# HOSHIZAKI AMERICA, INC.

## SERVICE BULLETIN

**SB13-0010**  
**October 11, 2013**

### **Subject: KMS Control Wire Bundle**

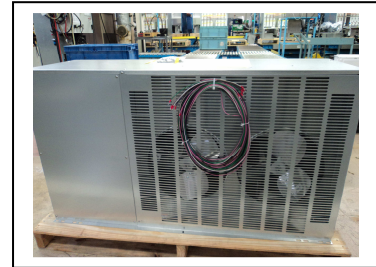
A recent change was made to the control wire bundle for all KMS /SRK products. Originally, the control wire bundle was sheathed and was connected and wire tied to the KMS unit.

This wire bundle has been changed as follows:

1. The sheathing was removed in response to issues with local codes and running sheathed control wiring through a roof penetration.
2. The wire bundle length is now 35' to match the common line set length.
3. The wire bundle was also moved to the SRK unit and is now wire tied to the fan grill as shown in the picture. It is no longer connected, as water tight conduit is required from the condenser through the roof penetration and the wiring would have to be disconnected to install the conduit connector.
4. The condenser is the location of choice as it is easier to route the wire bundle down to the KMS unit head than to feed the harness uphill to the condenser.
